Duke Energy Carolinas, LLC (Duke Energy)  
McGuire Nuclear Station (MNS), Units 1 and 2  
Docket Numbers 50-369, 50-370  
Renewed License Numbers NPF-9 and NPF-17

**Subject:** Response to August 28, 2014, NRC Request for Additional Information Regarding License Amendment Request to Implement a Risk-Informed Performance-Based Fire Protection Program (TAC Nos. MF2934 and MF2935).

Response to October 27, 2014, NRC Request for Additional Information Regarding License Amendment Request to Implement a Risk-Informed Performance-Based Fire Protection Program (TAC Nos. MF2934 and MF2935).

**Figure FM-01.j(1)**

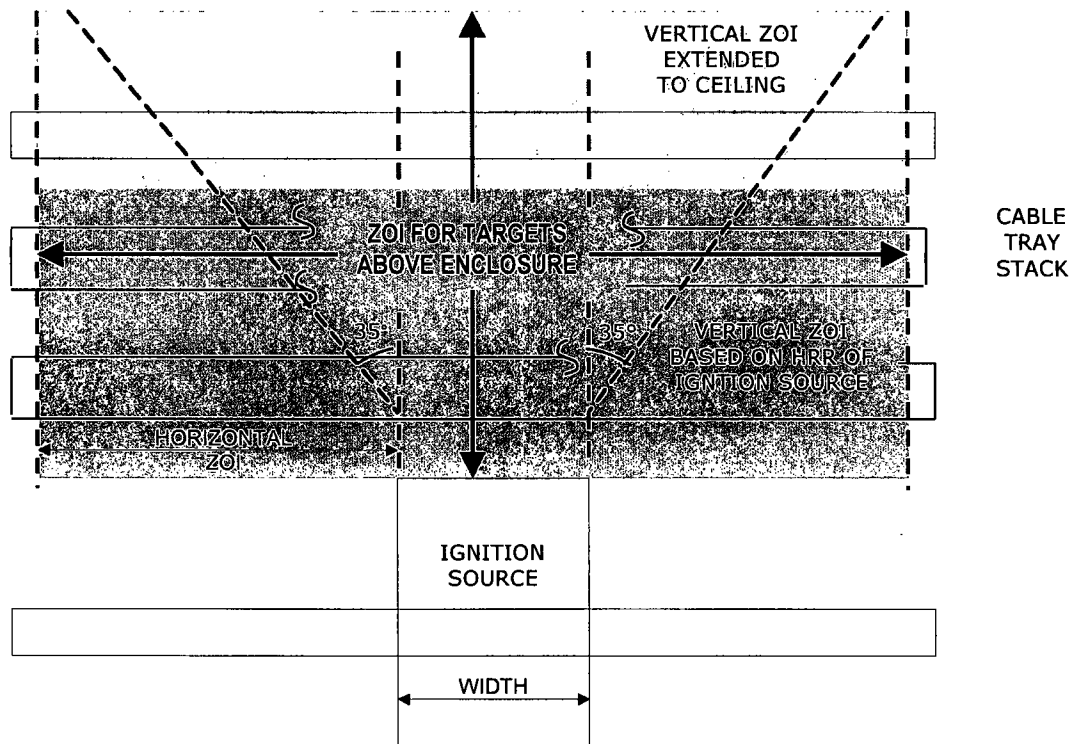
- j. Regarding the flame spread and fire propagation in cable trays:

Section V.2.3 of the LAR and the licensee's response to F&O FSS-C2-01 indicate that the licensee did not calculate fire propagation in, and the resulting HRR of, cable trays as described NUREG/CR-6850, Section R.4.2. The licensee's justification appears to be based on EIR 51-9160514-000, which as stated in the response to F&O FSS-C2-01, "... suggests that armored cables will not contribute to fire growth and spread ..." (see LAR, Attachment V, page V-8).

1. During the audit the NRC staff reviewed the summary in EIR 51-9160514-000 of selected results of a test program conducted by the licensee, and determined on the basis of this summary that the horizontal flame spread rate over armored cable with a PVC jacket in the test was between 0.5 and 2.2 mm/s.
2. During the audit plant walkdowns the NRC staff noticed several trays in different areas of the plant that appeared to contain some unarmored cable (for example, tray 3972 in Fire Area 13). The NRC staff notes that for thermoplastic and thermoset cables NUREG/CR-6850, Section R.4.1.2 recommends a flame spread rate of 0.9 mm/s or 0.3 mm/s, respectively.

3. During the audit the NRC staff reviewed the licensee's Design Basis Specification for Fire Protection and noted that 45% of the combustible mass of armored power cable, and 60% of the combustible mass of armored control cable is outside the armor. The contribution to the HRR from the PVC jacket around the armor is therefore expected to be not negligible.
4. FAQ 08-0049 provides guidance on calculation of cable tray ignition, fire propagation between cable trays, and HRR. The FAQ indicates that the licensee will need to develop and justify plant-specific, configuration-specific models if they are to be used outside the original ZOI, and that these models will be an area of detailed staff review.

In light of these observations the analysis should account for the impact of the horizontal flame spread, vertical fire propagation and the resulting additional HRR on the ZOI and HGL temperature timing determination for fires that involve cables. Provide a summary of this re-evaluation, including the impact on the risk and delta risk.

- j. As described in the Fire Scenario Report, Section 9.2, the MNS Fire PRA (FPRA) adequately accounts for fire propagation by applying a ZOI that identifies targets that would be damaged due to flame spread (i.e., horizontal progression of flame along a cable tray) and fire propagation (i.e., vertical progression of fire to additional cable trays). The horizontal ZOI used in the MNS FPRA exceeds the fire's "characteristic length," as described in NUREG/CR-6850, Section R.4.2, in order to account for flame spread. The vertical ZOI used in the MNS FPRA is extended to the ceiling, in order to account for fire propagation. This is reflected in Fire Scenario Report Figure 9-1, which shows how the horizontal ZOI encompasses the 35 degree angle discussed in NUREG/CR-6850, Section R.4.2, and depicted in NUREG/CR-6850 Figure R-5. Thus, the MNS FPRA methodology adequately incorporates fire propagation and flame spread in cable trays, as described in NUREG/CR-6850, Section R.4.2. This is depicted in Figure FM-01.j(1) below:

The intention of the response to F&O FSS-C2-01 is to indicate that the approach taken in the MNS FPRA is adequate, because the armored cables predominately used at MNS are not expected to contribute to fire growth and spread. However, no actual credit is given for cable armor within the FPRA.

Appendix H of NUREG-CR/6850 states that "cables in conduit will not contribute to fire growth and spread. The conduit will be given no credit for delaying the onset of thermal damage." Engineering Information Record EIR 51-9160514-000 compares the physical construction of cable in conduit to unjacketed armored cable, and concludes that the same logic (i.e., cables in conduit not contributing to fire growth and spread) could be applied to armored cable. The response to F&O FSS-C2-01 can be clarified to state that the comparison between cable in conduit and unjacketed armored cables, combined with the guidance provided in Appendix H of NUREG-CR/6850, "suggests that [unjacketed] armored cables will not contribute to fire growth and spread." ["unjacketed" added for clarification]. This statement does not address the outer PVC jacket on the armored cable typically employed at MNS.

Also explained more thoroughly in EIR 51-9160514-000, separately from the comparison between cable in conduit and unjacketed armored cables, a review of Electric Power Research Institute/Nuclear Energy Institute (EPRI/NEI) report 1003326 (Test #1 and Test #13 results) indicates that the outer PVC jacket did not contribute to fire growth or propagation when located in the HGL, when tested. Taken together, these qualitative conclusions indicate that no additional penalties or measures need be taken to address flame spread and fire propagation at MNS due to the extensive use of armored cable, both jacketed and unjacketed. Therefore, applying the guidance in NUREG/CR-6850, Section R.4.2, as done in the MNS FPRA, adequately accounts for flame spread and fire propagation in cable trays.

1. Regarding the horizontal flame spread rate of armored cable with a PVC jacket observed during tests that were evaluated in EIR 51-9160514-000, Duke Energy does not dispute the Staff's observation. As explained above, and as reflected in the Fire Scenario Report, Section 9.2, horizontal flame spread is adequately captured within the target set (i.e., the ZOI) of each scenario.

2. Tray 3972 in Fire Area 13 was confirmed to contain only armored cables. Most of the armored cables at MNS employ an interlocking steel armor that is often visible beneath the contouring PVC jacket. However, some of the armor is either smooth metallic tape or braided flat wires and are not readily distinguishable from non-armored cables. However, no actual credit is given for cable armor within the FPRA. The flame spread rate found in NUREG/CR-6850, Section R.4.1.2 is adequately captured within the target set (i.e., the ZOI) of each scenario.

3. Regarding the referenced figure in the Design Basis Specification for Fire Protection, combustible mass values were not used in the MNS FPRA, and the values provided in this single figure are not intended to be used as accurate values for all cable types and configurations. For example, the quantity of cable filler material varies between cable types and configurations, and would impact the percent of combustible material outside the cable armor. The MNS FPRA adequately accounts for cable flame spread and fire propagation within the target set (i.e., the ZOI) of each scenario.

4. The MNS FPRA does not model cable flame spread and fire propagation outside of the original ZOI, because the MNS FPRA adequately accounts for cable flame spread and fire propagation within the target set (i.e., the ZOI) of each scenario. Therefore, no plant-specific, configuration-specific models were developed.
